Access Compliance Report

Public Rights-of-Way (Curb Ramps)

Intersection ID: 2777	Main Street: PIPESTONE_LN	Cross Street: SKYLINE_DR	Location: SW
ADA ID: D5EA97B71399	Ramp Type: BlendTrans1	Initial Pass/Fail: Fail	Overall Compliance: No
			Severity Score: 33.75

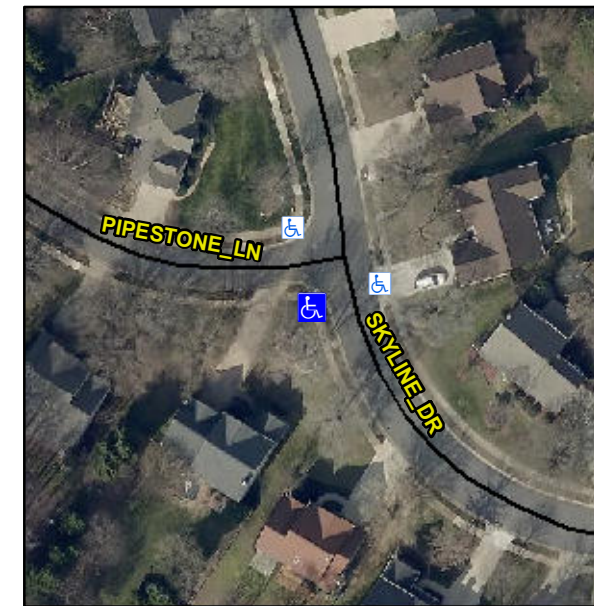
DAMAGED GTR

Not Found, R304.5.1, R304.5.3

Compliance	Description	Data	Compliance	Description	Data
N/A	Ramp Length (in)	48.0	Yes	BlendTrans Slope (%)	3.9
No	Ramp Width (in)	38.0	No	BlendTrans XSlope (%)	11.7
N/A	Flare Type LT	N/A	N/A	Flare Type RT	N/A
N/A	Flare Slope LT (%)	N/A	N/A	Flare Slope RT (%)	N/A
N/A	Flare Traversable LT?	N/A	N/A	Flare Traversable RT?	N/A
N/A	Landing Length (in)	N/A	N/A	DWS Provided?	N/A
N/A	Landing Width (in)	N/A	N/A	DWS Contrast?	N/A
N/A	Landing Slope (%)	N/A	N/A	DWS Length (in)	N/A
N/A	Landing X Slope (%)	N/A	N/A	DWS Full Width?	N/A
N/A	Landing Curb? (Y/N)	N/A	N/A	DWS Offset (in)	N/A
N/A	Shared Landing?	N/A			
N/A	Gutter Ponding?	N/A	N/A	Gutter Slope (%)	N/A
N/A	Gutter Lip Ht (in)	N/A	N/A	Gutter X Slope (%)	N/A
N/A	Painted X Walk1?	No	N/A	Painted X Walk2?	No
	X Walk 1 Direction	To NE		X Walk 2 Direction	To NW
	X Walk 1 Width (in)	N/A		X Walk 2 Width (in)	N/A
	X Walk 1 Slope (%)	1.6		X Walk 2 Slope (%)	7.6
	X Walk 1 X Slope (%)	7.5		X Walk 2 X Slope (%)	4.0

N/A	Ramp inside XWalk1?	N/A	N/A	Ramp inside XWalk2?	N/A
	Road Slope (%)	10.7		Clear Space?	N/A
	Road X Slope (%)	2.0	N/A	Clear Space to XWalk (in)	N/A
N/A	Any Obstructions?	N/A	N/A	Storm Grate/Utility Hazard?	N/A
	Obstruction Type			Storm Grate/Utility Type	
		N/A			N/A
			Yes	Surface Condition? (G/P)	Good
			No	Curb Slope (%)	12.5

Remove & Replace Curb Ramp With Two New Directional Ramps or Equivalent.
